# 2

## Description of Proposed Changes

## 2.2 Proposed Refinements to Project Design

Figure 2-2: Illustration of Proposed Refinements – UNC Hospitals Station

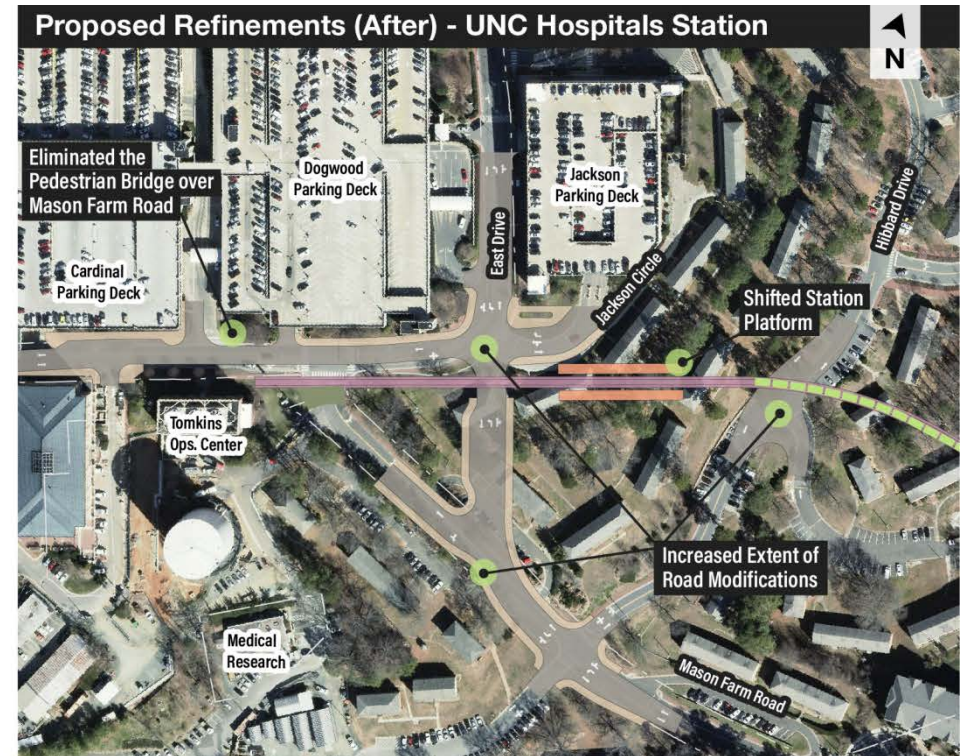
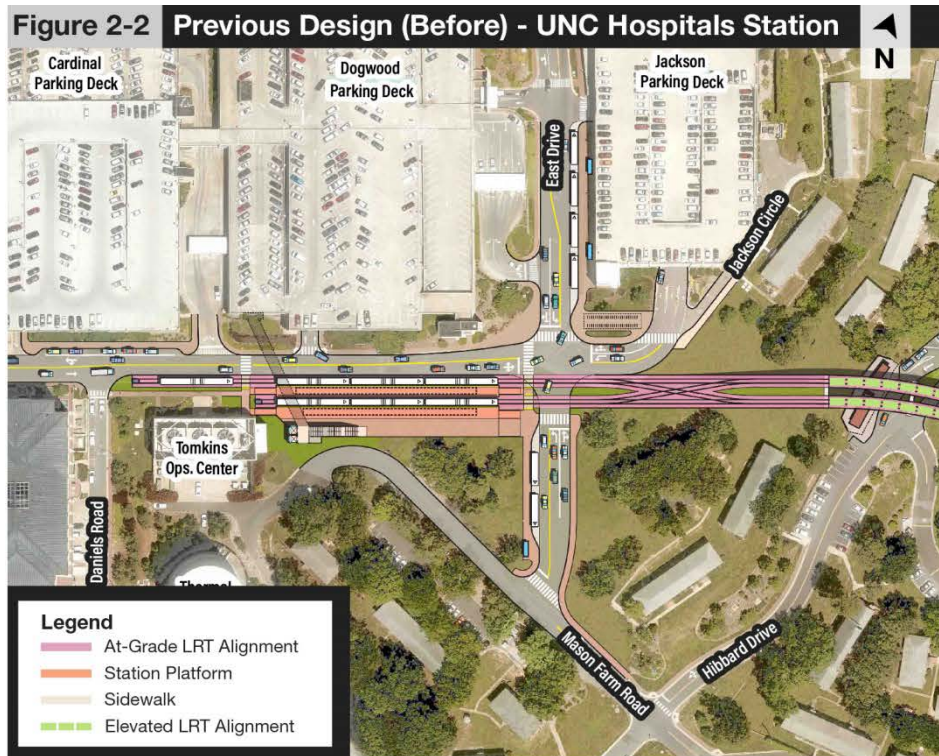
Location	What's Changed?	Why?
UNC Hospitals Station (Figure 2-2 & appendix A-1, Sheet 1)	<ul style="list-style-type: none"> <li>▪ Increased the extent of roadway modifications in the station area.</li> <li>▪ Eliminated the proposed pedestrian bridge between the station and the Dogwood Parking Deck on the north side of Mason Farm Road.</li> <li>▪ Shifted station platforms from west of East Drive to 350 feet to the east, of East Drive.</li> </ul>	<ul style="list-style-type: none"> <li>▪ In the Amended ROD, GoTriangle committed to perform a detailed traffic study in this area (Mitigation ID # R02).</li> <li>▪ Changes would improve vehicular and pedestrian access to and from station, hospitals, and nearby parking decks.</li> <li>▪ UNC requested the elimination of the pedestrian bridge to better accommodate the anticipated pedestrian volume from the station to destinations within the station area.</li> <li>▪ By shifting the platforms east, pedestrian access would be provided along East Drive, which improves station access.</li> </ul>

**Figure 2-4: Illustration of Proposed Refinements – Friday Center Drive Station**

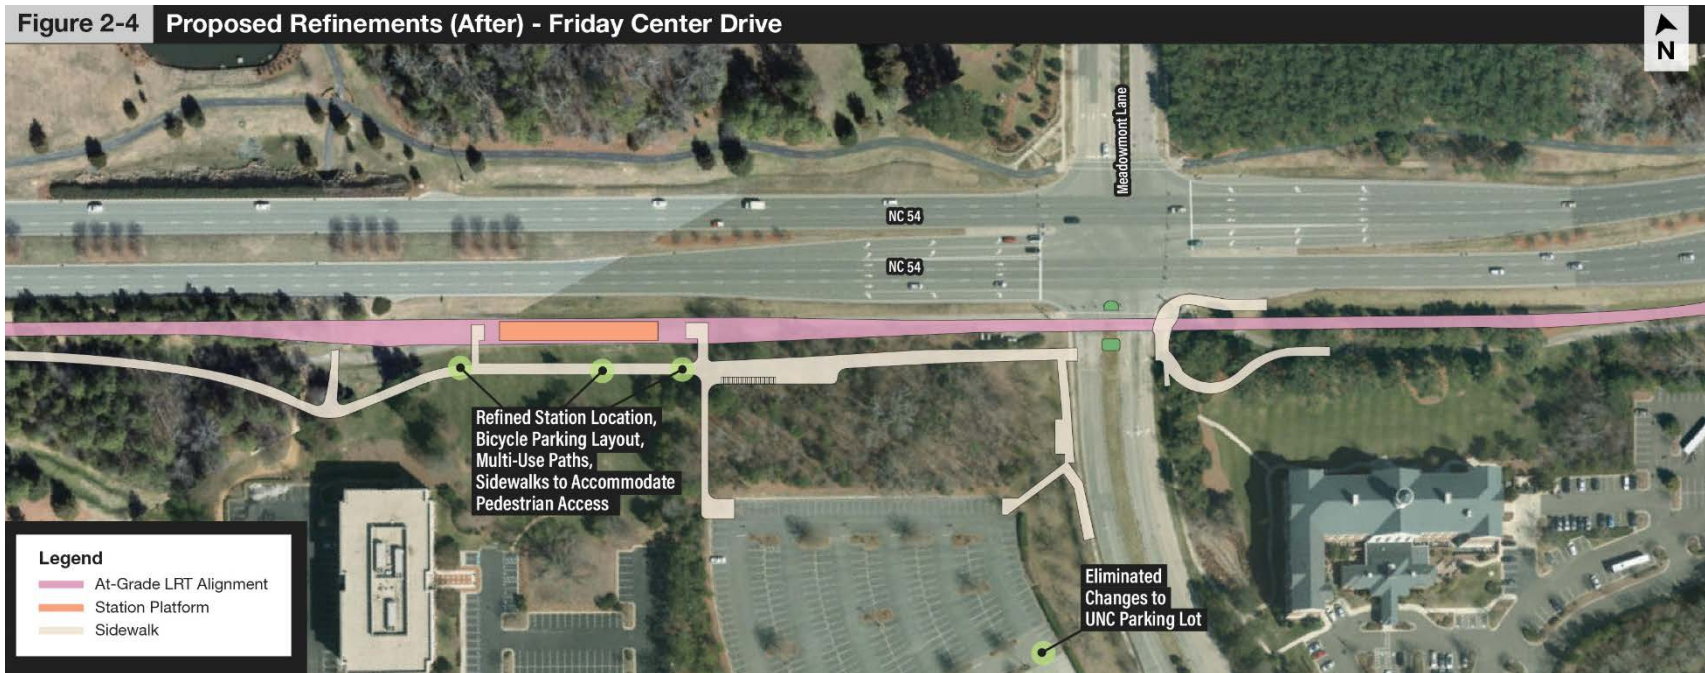
Location	What's Changed?	Why?
Hamilton Road Station (appendix A-1, Sheet 4)	<ul style="list-style-type: none"> <li>Added sidewalk along the west side of Burning Tree Drive from NC 54 to Oak Tree Drive.</li> <li>Added a multi-use path along north side of NC 54 from Oakwood Drive to Burning Tree Drive.</li> </ul>	<ul style="list-style-type: none"> <li>In the Amended ROD, GoTriangle committed to refine the design to enhance sidewalk connections and improve bicycle and pedestrian access to stations (Mitigation ID # PBF01).</li> </ul>
Friday Center Drive Station (Figure 2-4 and appendix A-1, Sheet 5)	<ul style="list-style-type: none"> <li>Eliminated Previous Design changes to the existing UNC-owned park-and-ride lot.</li> <li>Refined station location, bicycle parking layout, and multi-use path and sidewalk design to improve the connection to the existing pedestrian underpass and parking lot.</li> <li>Added a sidewalk along east side of Friday Center Drive from Marriott Way to bus shelter.</li> </ul>	<ul style="list-style-type: none"> <li>UNC requested elimination of Previous Design changes to the existing UNC-owned park-and-ride lot.</li> <li>The station design refinement would provide pedestrian access to the station while still preserving the use, flexibility, and long-term maintenance of the existing parking lot for consistency with UNC's plans.</li> <li>In the Amended ROD, GoTriangle committed to refine the design to enhance sidewalk connections and improve bicycle and pedestrian access to stations (Mitigation ID # PBF01).</li> </ul>

**Figure 2-7: Illustration of Proposed Refinements – I-40**

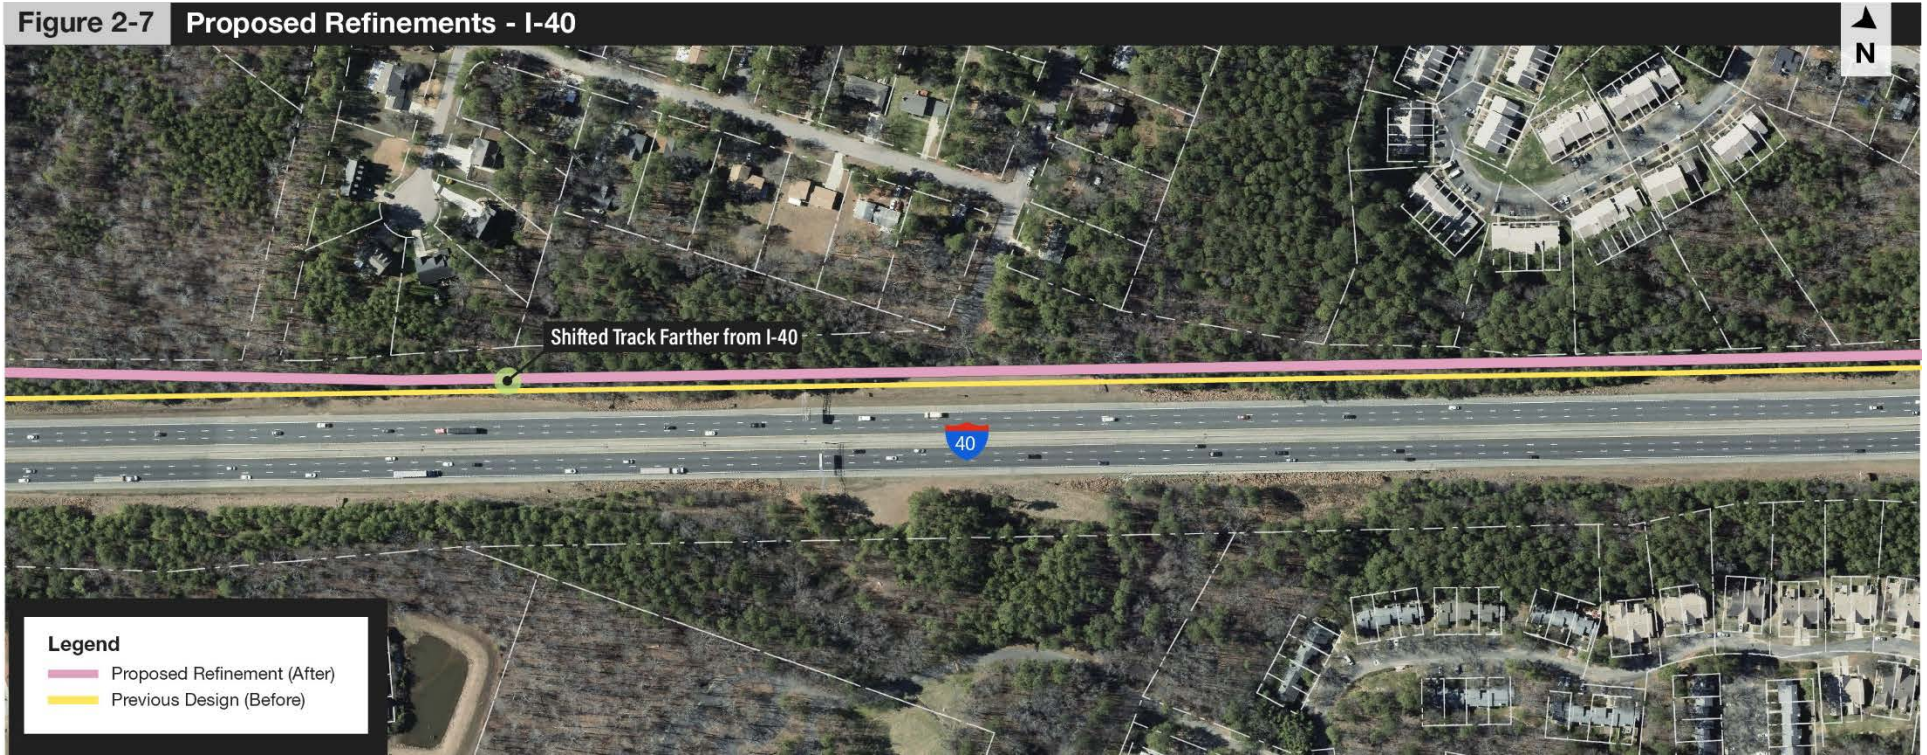
Location	What's Changed?	Why?
Realignment in Vicinity of I-40 (Figure 2-7 and appendix A-2, Sheet 12)	<ul style="list-style-type: none"> <li>Shifted the track alignment along I-40 farther from the existing shoulder of the eastbound I-40 travel lane.</li> </ul>	<ul style="list-style-type: none"> <li>The North Carolina Department of Transportation (NCDOT) requested that GoTriangle offset the light rail alignment farther from I-40 to minimize encroachment into the NCDOT controlled access area, to increase separation between the light rail tracks and I-40, and to accommodate future widening plans along I-40.</li> </ul>

Figure 2-8: Illustration of Proposed Refinements – Gateway Station

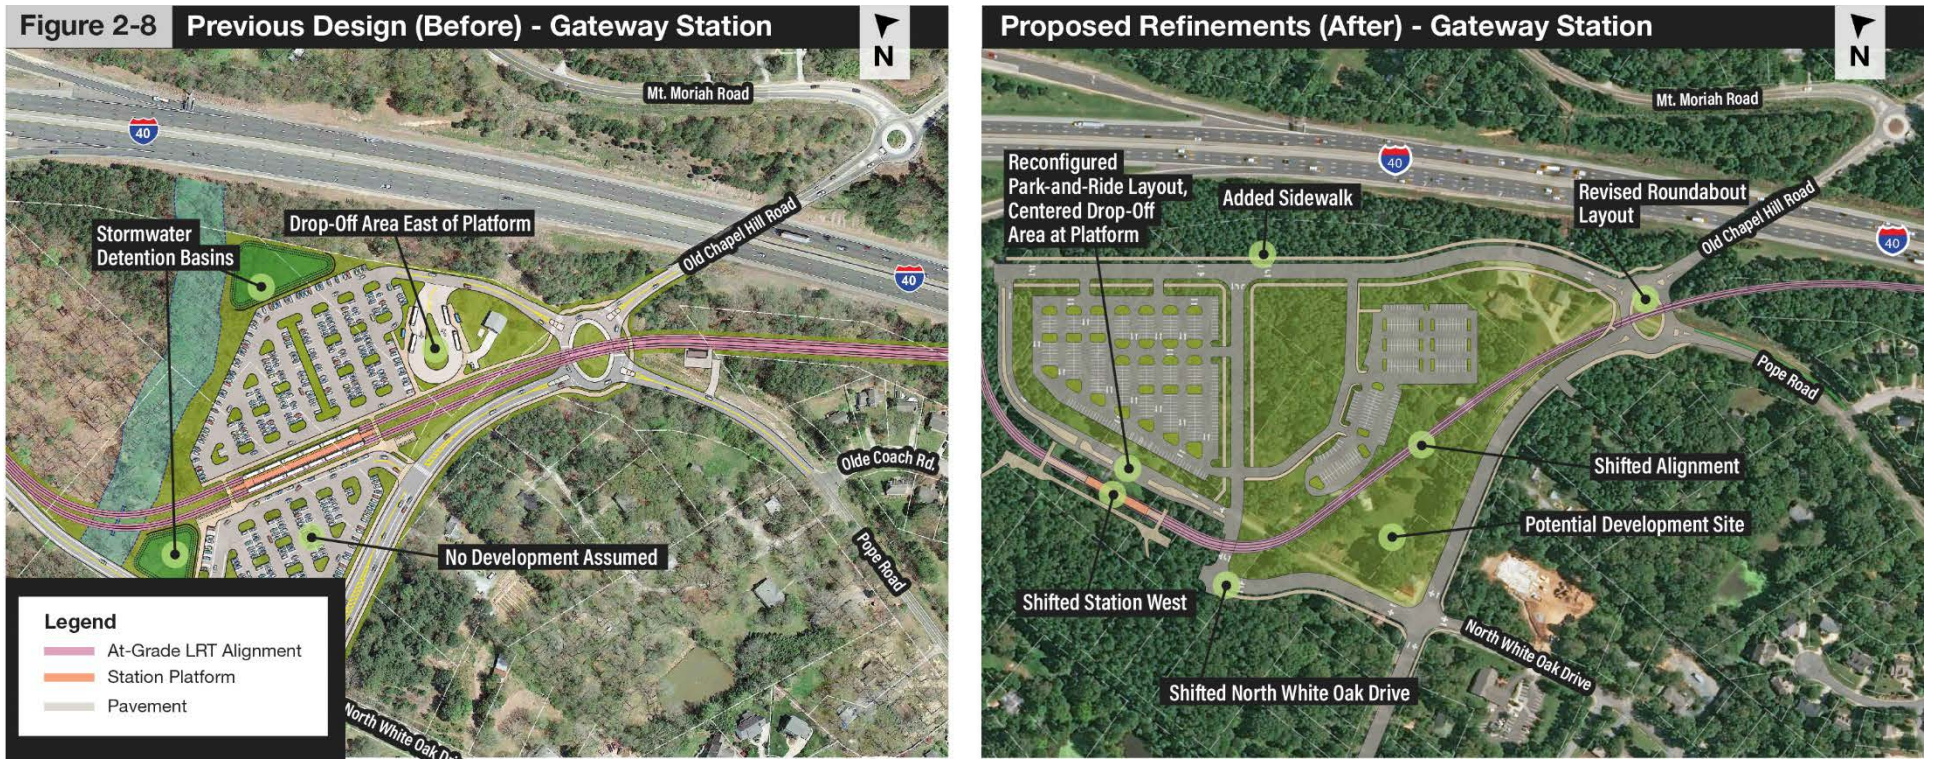
Location	What's Changed?	Why?
Gateway Station (Figure 2-8 and appendix A-2, Sheets 13, 14)	<ul style="list-style-type: none"> <li>▪ Moved the station to the west and reconfigured the station, shifted North White Oak Drive, reconfigured the park-and-ride site layout, and revised the alignment to accommodate the station relocation.</li> <li>▪ Revised the roundabout layout to include a single roundabout lane instead of two lanes. The eastbound to southbound and westbound to northbound slip lanes would be removed and the approach and geometry of the lanes would be modified.</li> <li>▪ Added a sidewalk along the east side of Pope Road from Olde Coach Road to Chapel Hill Road.</li> <li>▪ Identified the Gateway Station park-and-ride site as a potential joint development site. At this time, the Proposed Refinements do not include activities or improvements specifically tied to a joint development project; rather, the design refinements include acquisition and site preparation for a park-and-ride facility that may also support a future joint development (redevelopment).</li> </ul>	<ul style="list-style-type: none"> <li>▪ The change in station location would increase potential economic development benefits for both Orange and Durham counties.</li> <li>▪ The change to the park-and-ride site layout would make it conducive to urban redevelopment.</li> <li>▪ Since publication of the Amended ROD, GoTriangle engaged a task force of local stakeholders, including representatives from local governments, regional agencies, and the Durham Housing Authority to identify potential joint development sites in the D-O LRT Project Corridor. The task force identified and evaluated over 30 potential sites and recommended four sites for further study, including the Gateway Station park-and-ride.</li> </ul>

Figure 2-9: Illustration of Proposed Refinements – Patterson Place Station

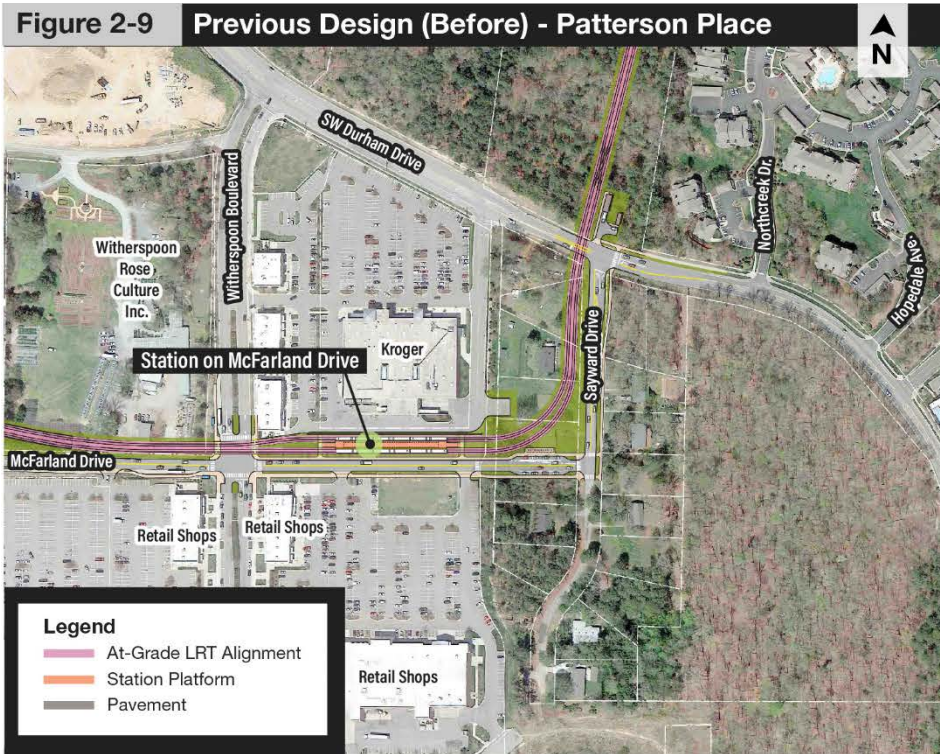
Location	What's Changed?	Why?
Patterson Place Station (Figure 2-9 and appendix A-2, Sheets 15-17)	<ul style="list-style-type: none"> <li>▪ Shifted the station platform approximately 500 feet to the northeast).</li> <li>▪ Revised the track alignment across Southwest Durham Drive and removed retaining walls (.).</li> <li>▪ Reconfigured Sayward Drive to accommodate station and track alignment.</li> <li>▪ Revised from a double-track to a single-track alignment between Patterson Place Station and Martin Luther King Jr. Parkway Station, approximately from Southwest Durham Drive to Snow Crest Trail near University Drive. Track switches (i.e. single-track turnouts) to connect the double-track alignment with the single-track section, would be added at both ends of the single-track section. Single-track bridge structures would extend over New Hope Creek, Garrett Road and Sandy Creek.</li> </ul>	<ul style="list-style-type: none"> <li>▪ The changes would improve access to and visibility of the station in accordance with the TOD study.</li> <li>▪ The changes would better situate the station for potential future development, unlike the Previous Design, which locates the station in a constrained area.</li> <li>▪ The changes would avoid creation of an uneconomic remnant parcel north of Southwest Durham Drive, which is part of the Previous Design.</li> <li>▪ The grant-funded TOD study recommended optimizing the platform location for future development.</li> <li>▪ The VE study identified the revision to a single-track section as a cost savings measure, which also avoids the need to relocate the City of Durham's 16-inch water line in the New Hope Creek Bottomlands and minimizes ground disturbance impacts to natural resources and water resources.</li> </ul>

Figure 2-10: Illustration of Proposed Refinements – Martin Luther King Jr Parkway Station

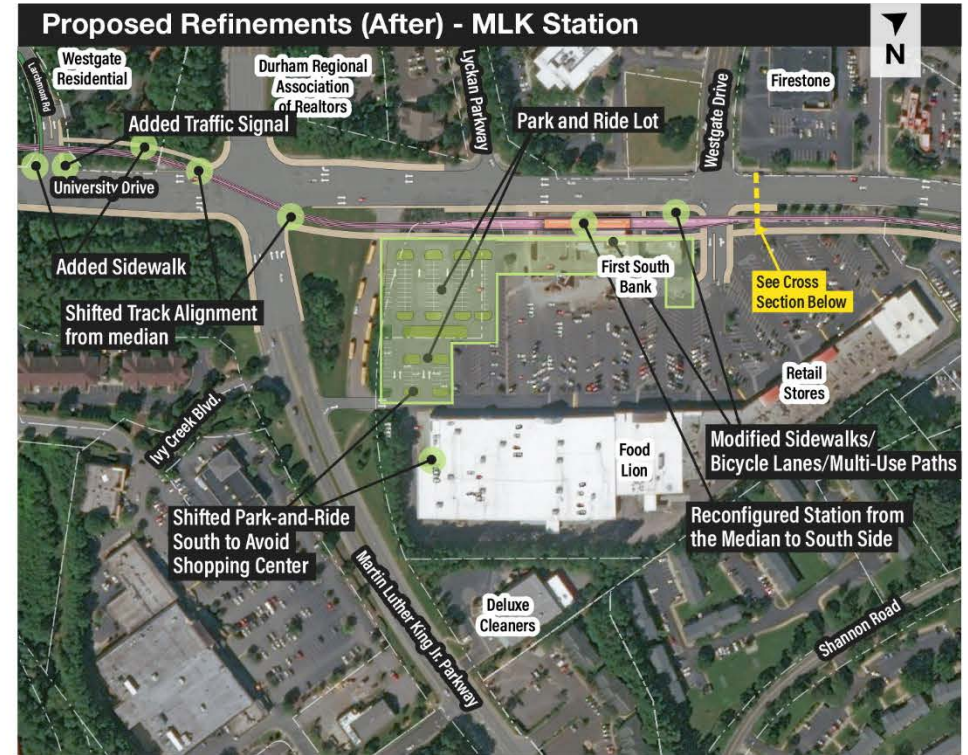
Location	What's Changed?	Why?
University Drive and Martin Luther King Jr. Parkway Station (Figures 2-10 to 2-11, and appendix A-2, Sheet 18)	<ul style="list-style-type: none"> <li>▪ Revised the track design from median-running with significant roadway reconstruction, including additional turn lanes, to side-running. Realigned the track from the median to the shoulder on the north side of University Drive between Snow Crest Trail and Martin Luther King Jr. Parkway, crossing at-grade on a diagonal through the intersection of Martin Luther King Jr. Parkway to the south side of University Drive.</li> <li>▪ Added traffic signals at the existing intersections of University Drive with Larchmont Road and the BB&amp;T Plaza Drive.</li> <li>▪ Moved the station from the median to the south side of University Drive.</li> <li>▪ Modified sidewalks, bicycle lanes, and multi-use paths to improve access to the relocated station.</li> <li>▪ Added a sidewalk along the west side of Larchmont Road between University Drive and Gatehouse Lane.</li> <li>▪ Reconfigured the park-and-ride lot to the south, closer to Martin Luther King Jr Parkway, which avoided the acquisition of a big box store and required the acquisition of two bank properties.</li> </ul>	<ul style="list-style-type: none"> <li>▪ In the Amended ROD, GoTriangle committed to perform an additional traffic analysis and coordinate with NCDOT, Durham-Chapel Hill-Carrboro Metropolitan Planning Organization (DCHC MPO), and municipalities to address traffic impacts at the intersection of University Drive and Martin Luther King Jr. Parkway (Mitigation ID # R01). The revised track design would minimize roadway reconstruction because University Drive would not need to be widened to accommodate the light rail.</li> <li>▪ The changes would enhance pedestrian and bicycle connectivity and access across University Drive and in the vicinity of the intersection of University Drive and Martin Luther King Jr. Parkway, consistent with GoTriangle's commitments in the Amended ROD (Mitigation IDs # PBF01, PBF03).</li> <li>▪ By not widening University Drive, both access and waiting conditions for riders would be improved and would align with the City's compact development goals for the area.</li> <li>▪ The VE study identified moving the park-and-ride lot to the south as a cost savings measure to avoid acquisition of the commercial retail "big box" store.</li> <li>▪ In the Amended ROD, GoTriangle committed to perform additional engineering design work and seek to avoid or limit impacts to existing utilities (Mitigation ID # UI01). The changes would avoid the need to relocate a major communications hub facility near Snow Crest Trail and University Drive.</li> </ul>

Figure 2-12: Illustration of Proposed Refinements – South Square Station

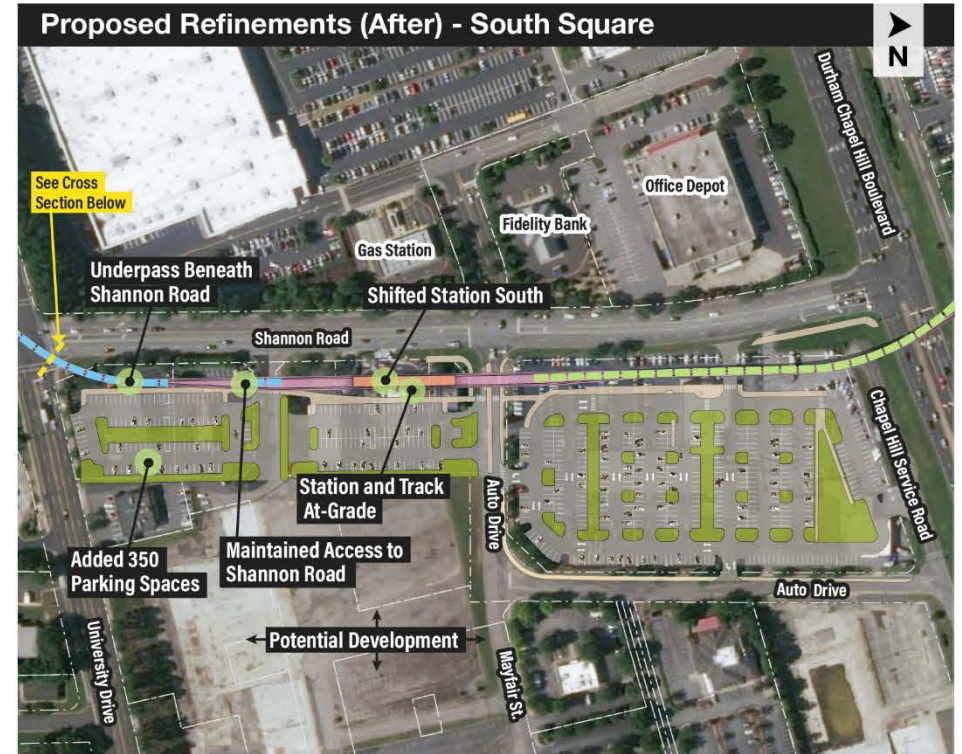
Location	What's Changed?	Why?
<p>South Square Station                      (Figures 2-12, 2-13 and appendix A-2, Sheet 19)</p>	<ul style="list-style-type: none"> <li>▪ Revised the alignment through the intersection of University Drive and Shannon Road to pass underneath the intersection in an underpass instead of crossing through the intersection at-grade.</li> <li>▪ Revised the location of the station approximately 220 feet to the south, locating the station at-grade south of Auto Drive, instead of elevated north of Auto Drive.</li> <li>▪ Maintained access from the new park-and-ride lot to Shannon Road.</li> <li>▪ Added 350 new park-and-ride spaces (for total of approximately 600 spaces) on portions of parcels identified as acquisitions for the track alignment and park-and-ride in the Previous Design.</li> <li>▪ Identified the South Square Station park-and-ride site as a potential joint development site. At this time, the Proposed Refinements do not include activities or improvements specifically tied to a joint development project; rather, the design refinements include acquisition and site preparation for a park-and-ride facility that may also support a future joint development (redevelopment).</li> </ul>	<ul style="list-style-type: none"> <li>▪ In the Amended ROD, GoTriangle committed to incorporate roadway safety measures into the design refinements, such as shifting the light rail alignment horizontally or vertically away from vehicular traffic (Mitigation ID # R04). The underpass design in the Proposed Refinements eliminates a complex at-grade crossing through the intersection of University Drive and Shannon Road.</li> <li>▪ Additional parking is more consistent with projected park-and-ride demand in this portion of the corridor.</li> <li>▪ Since publication of the Amended ROD, GoTriangle has engaged a task force of local stakeholders, including representatives from local governments, regional agencies, and the Durham Housing Authority, to identify potential joint development sites in the D-O LRT Project Corridor. The task force identified and evaluated over 30 potential sites and recommended four sites for further study, including the South Square Station park-and-ride.</li> </ul>
